**PROPOSED MINOR RELAXATION OF NON-BUILDING AREA RESTRICTION FOR  
PROPOSED FOOTBRIDGE CONNECTIONS AT MA SIK ROAD,  
FANLING, NEW TERRITORIES (FSSTL NO. 297)  
(TPB Ref: A/FLN/33)**

Further to comments received from Urban Design and Landscape Unit of Planning Department on 15 August 2025 and the Public, please find attached the Responses-to-Comments ("R-to-C") table in **Attachment 1** which has fully addressed the comments received. Please note that these responses are clarifications only and there are no changes to the S16 Planning Application.

**PROPOSED MINOR RELAXATION OF NON-BUILDING AREA RESTRICTION FOR PROPOSED FOOTBRIDGE CONNECTIONS AT MA SIK ROAD, FANLING, NEW TERRITORIES(FSSTL NO. 297) (TPB REF: A/FLN/33)**

Figure 8-1 Section of the Proposed Footbridge Connections

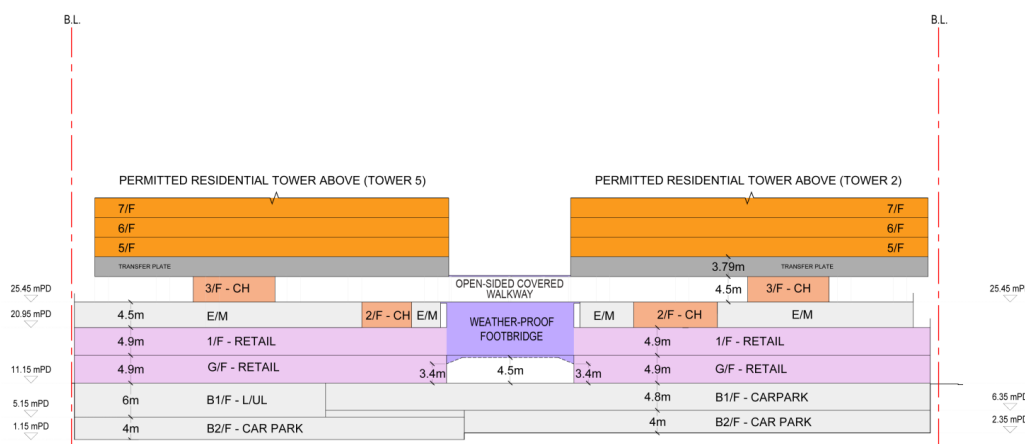
Comments/ Suggestions		Applicant's Responses
8.	Please clarify what is the top level of the footbridges. According to the section A-A, an open-sided covered walkway with a height of 4.5m is erected above the fully enclosed footbridge at 25.45mPD. Please review whether the description of "the top level of the footbridge us merely about 25mPD" at para. 9.1.3 is accurate.	Please note that the top level of the weather-proof footbridge is approx. 25.45mPD and the level of the 2m-wide canopy of the open-sided walkway is at approx. 29.95mPD.  Para. 9.1.3 of the AVA-EE has been revised as follows accordingly: "..... clearance of around 3.4m to 4.5m from the ground is provided for the Proposed Footbridge Connections and the top level of the <b>weather-proof footbridge</b> is merely about 25mPD..." ( <b>Appendix 2</b> refers).

- 8.2.2. The structures of the Proposed Footbridge Connections are only minimal -- its proportion to the site coverage is merely not more than 12.96 % of the NBA. A wake zone would be created on the immediate leeward side of the Proposed Footbridge Connections. However, since the top level of the weather-proof footbridge is about 25mPD as shown in **Figure 8-1**, it is expected that the adverse impact on downwind areas will be reduced due to its minimal obstruction. In addition, both sides of the open-sided covered walkway will be equipped with a 1100mm high non-perforated glass fence wall, leaving a 3.4m open perforation at the top, it poses minimal obstruction to the incoming wind and would not induce significant obstruction to the downwind areas.

- 10.1.4. To reduce any ventilation impact, the Proposed Footbridge Connections are erected that leaving a clearance of around 3.4m to 4.5m from the ground. Since the top level of the weather-proof footbridge is merely about 25mPD, it is expected that the adverse impact on downwind areas will be minimal due to the relatively small structure of Proposed Footbridge Connections. It is anticipated that the incoming wind at low-level could penetrate through and will not be significantly affect the wind environment at pedestrian level. In addition, there would be no obstruction in the NBA at high-level and the high-level prevailing wind could flow freely through the Application Site.
